SUMMIT WATER QUALITY COMMITTEE

March 11, 2010

Ref: SWQC Comments on Moffat Collection System DEIS

Figure 1

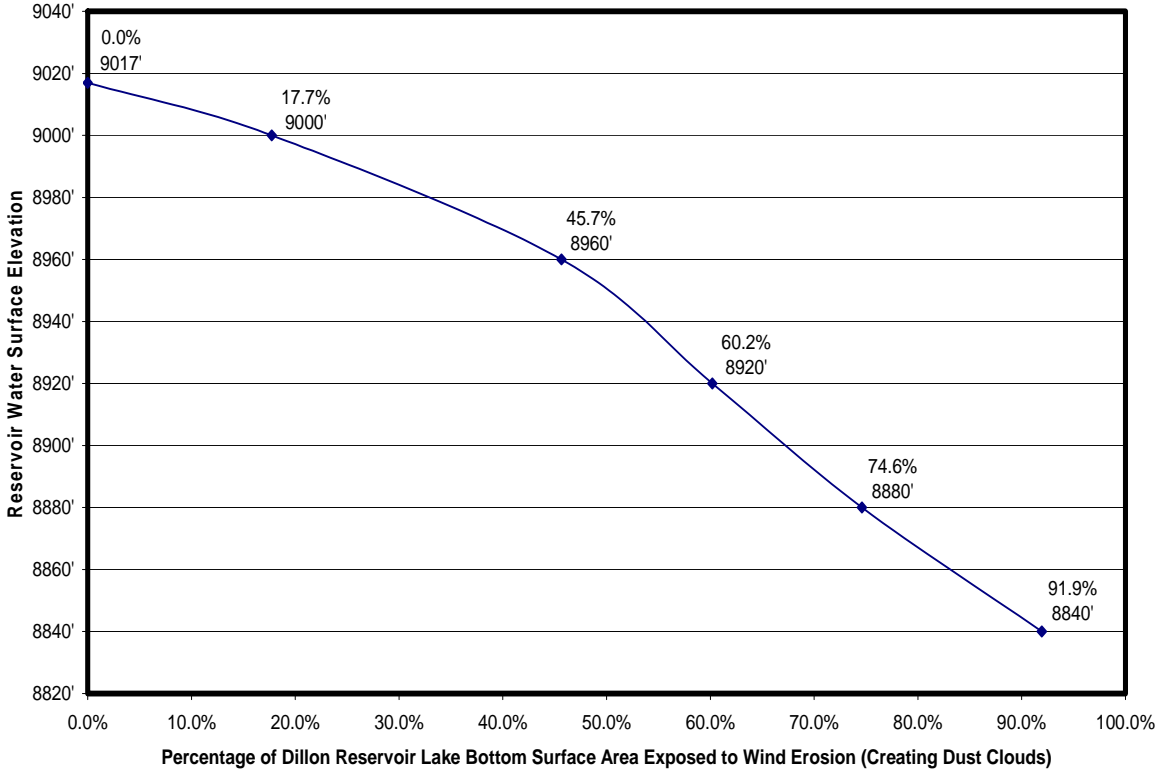
4. Neither the water quality or the air quality sections of the DEIS recognize the potential for increased fugitive dust. One of the largest contributors of phosphorus loading to Dillon Reservoir is associated with precipitation (see Dillon Clean Lakes Study, Final Report, August 1983, Western Environmental Analysts, Inc.). Precipitation carries phosphorus bound to fine particulate matter into the reservoir.

The DEIS indicates the end of September reservoir elevation would be reduced by 3 feet on average; with a maximum monthly reduction of 16 feet (page 4-28). SWQC is concerned that increased shoreline exposure will result in an increase in fugitive dust. Increased fugitive dust would result in increased phosphorus loading through precipitation as the concentration of particulates in the air increases. Figures 1 and 2 below show how the reduction in reservoir level translates into increased exposed surface area with the potential for dust generation. This impact was seen in 2002 during the drought when there was a significant increase in shoreline exposure.

The DEIS does recognize that the Eagles Nest Wilderness Area, which virtually abuts Dillon Reservoir, is managed under the Clean Air Act as a Class I area suitable for the most stringent level of protection (page 3-262). The DEIS fails to recognize the potential for increased air and water pollution from fugitive dust. SWQC requests a 404 permit condition requiring the development of a fugitive dust control plan for the increasingly exposed shoreline area that will occur in the future as a result of the project.
